SUBJECT: ISSUANCE OF AMENDMENT NO. 15 TO FACILITY OPERATING LICENSE
NO. NPF-63 - SHEARON HARRIS NUCLEAR POWER PLANT, UNIT 1,
REGARDING CYCLE 3 RELOAD WITH VANTAGE 5 FUEL
(TAC NO. 72947)

The amendment changes the Technical Specifications to allow refueling and operation with Vantage 5 fuel design.

AMENDMENT NO. 15 TO FACILITY OPERATING LICENSE NO. NPF-63 - HARRIS, UNIT 1

ATTACHMENT TO LICENSE AMENDMENT NO. 15

**FIGURE 2.1-1
REACTOR CORE SAFETY LIMITS - THREE LOOPS IN OPERATION**

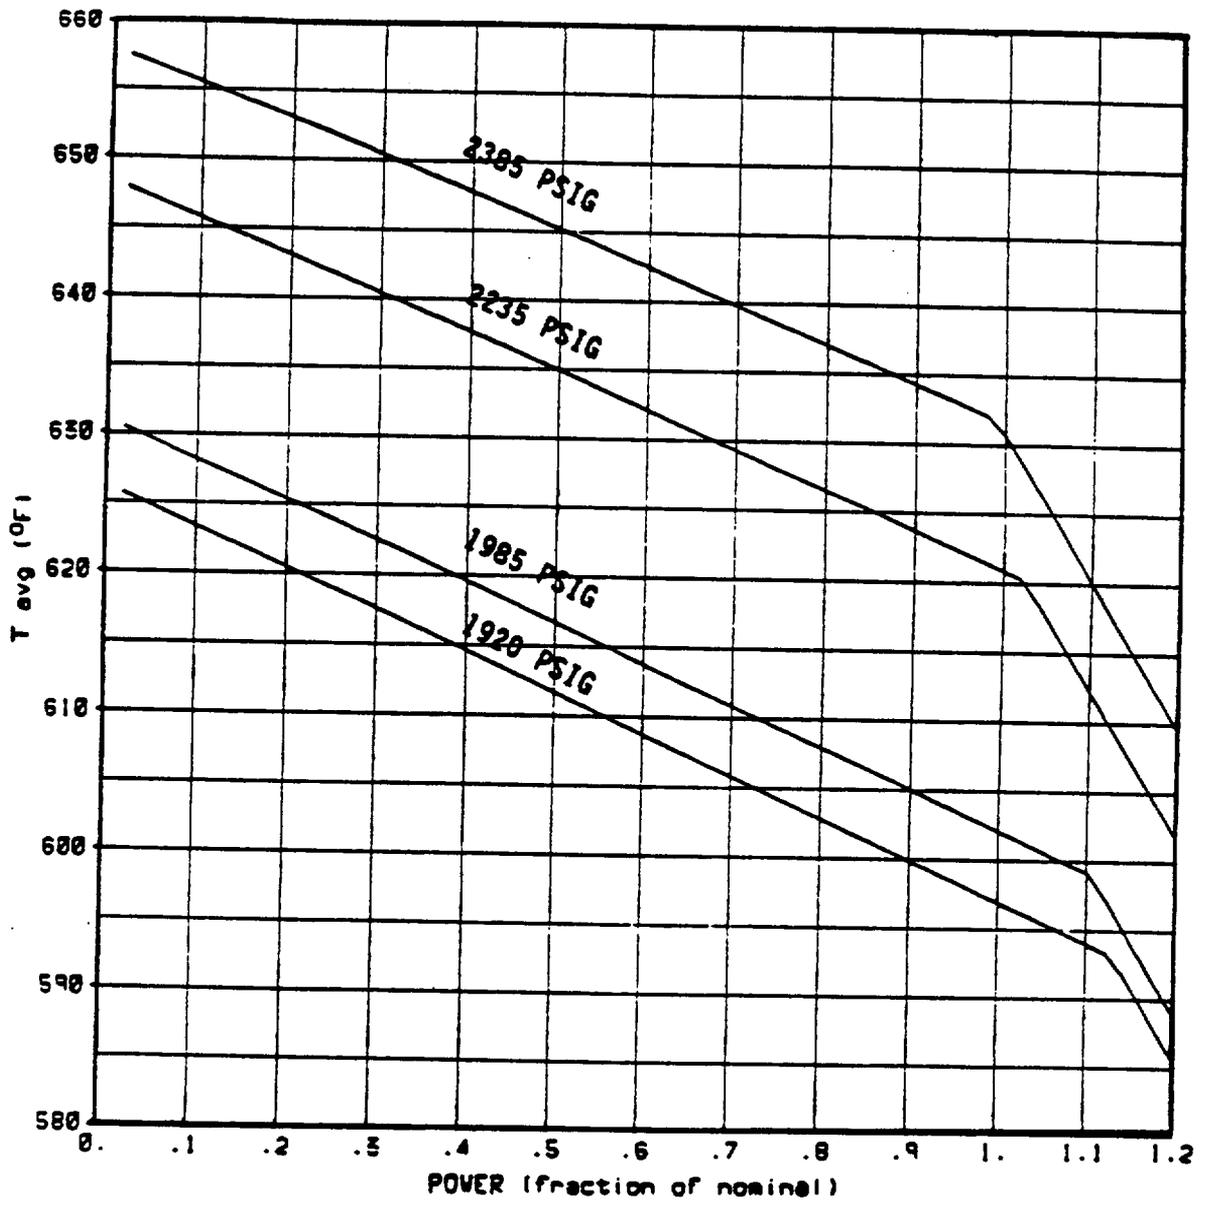
3.1 Core Safety Limits (Figure 2.1-1, 3/4.2.3 and Bases 2.1.1, 3/4.2, 3/4.2.5, 3/4.4.1)

The core safety limits are revised to reflect the use of VANTAGE 5, ITDP, WRB-1 (LOPAR fuel) and WRB-2 (VANTAGE 5 fuel) DNBR correlation and increased F_H (1.62 for LOPAR fuel and 1.65 for VANTAGE 5 fuel). Since the core safety limits are calculated based on the approved WCAP-10444-P-A, ITDP method, DNBR correlations and acceptable results of transient and accident analyses, the staff concludes that the revised core safety limits are acceptable.

3.2 Overpower/Overtemperature Setpoints (Figure 2.1-1, Table 2.2-1)

Since overpower and Overtemperature setpoints are revised to maintain consistency with the analyses to support the reload application, the revised overpower and overtemperature setpoints are acceptable.

FIGURE 3.2-2
 K(Z) - LOCAL AXIAL PENALTY FUNCTION FOR $F_0(Z)$

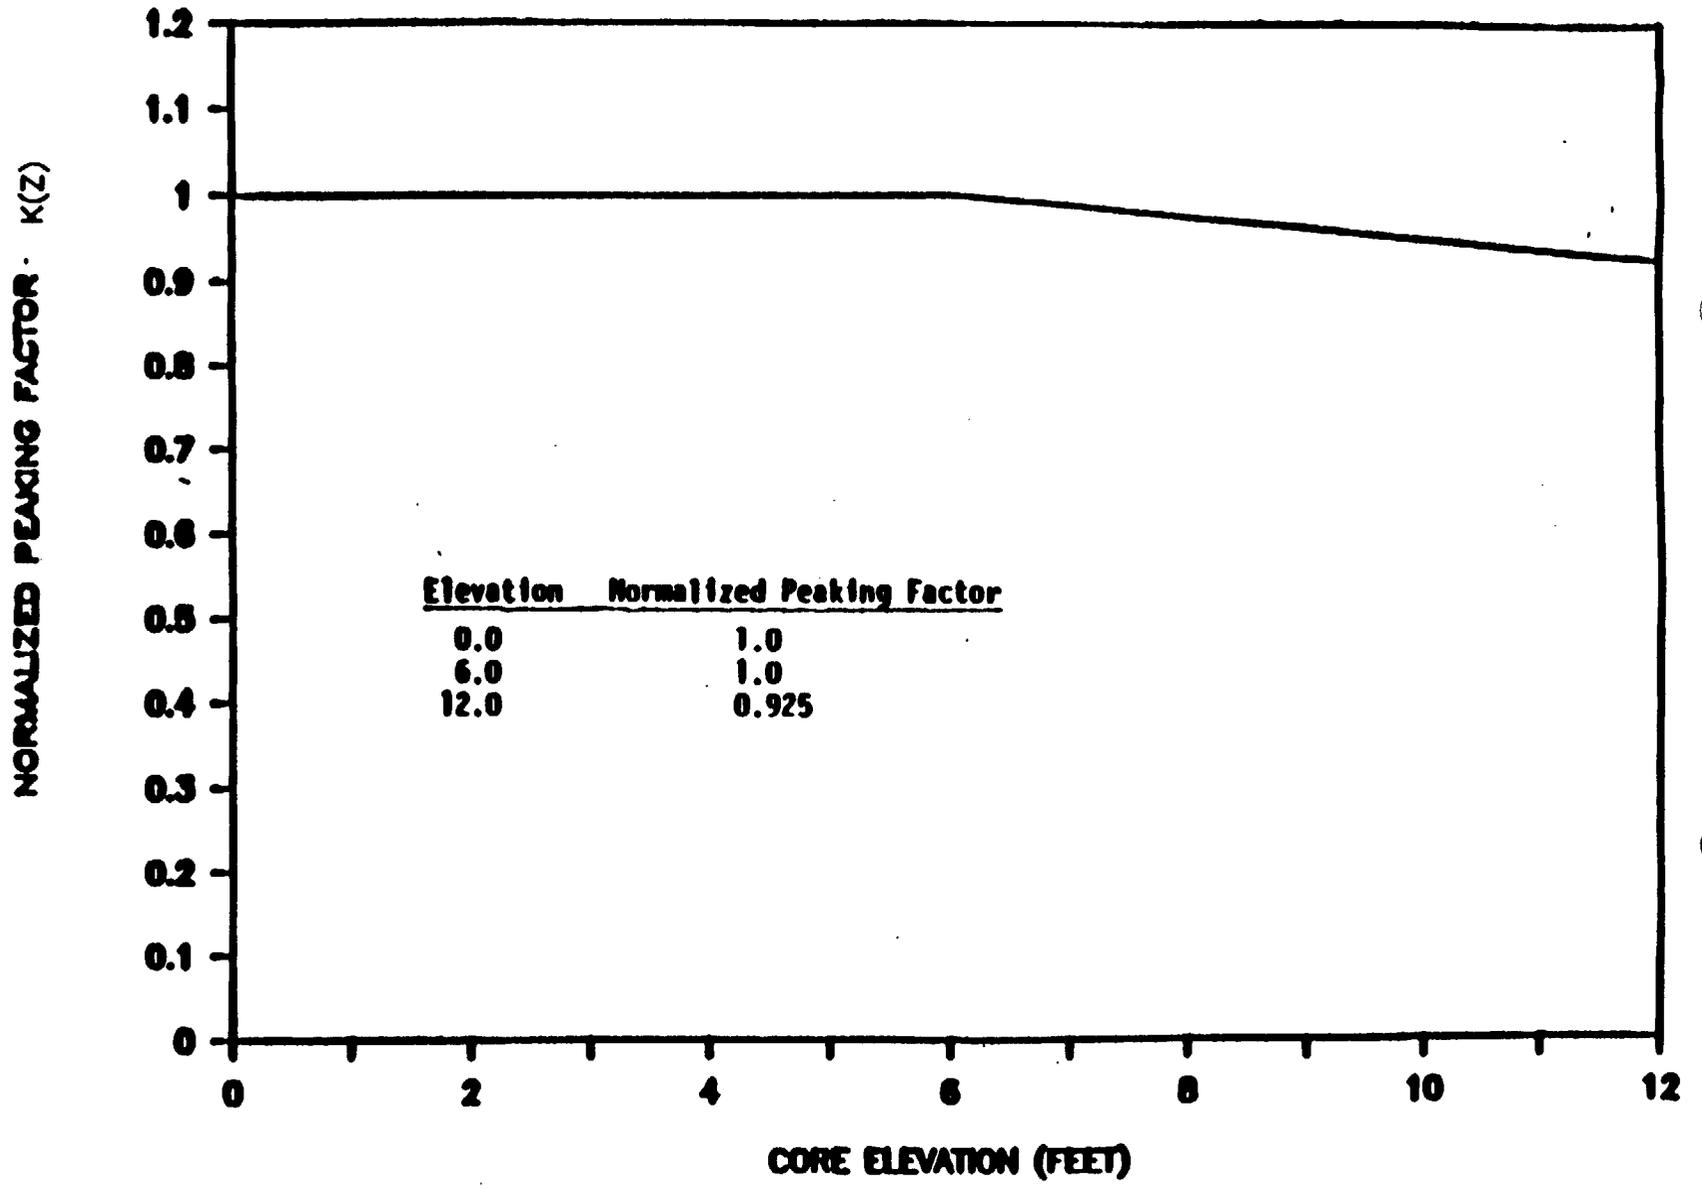
3.5 Hot Channel Factor- F_Q (3.2.2, 4.2.2.2, 4.2.2.3, 4.2.2.4, Figure 3.2-2 and Bases 3/4.2)

The maximum hot channel factor- F_Q is increased from 2.32 to 2.45 to allow for greater operational flexibility due to the use of VANTAGE 5 fuel. Since the F_Q of 2.45 was used in the analysis to support the reload application, the staff concludes this change is acceptable.
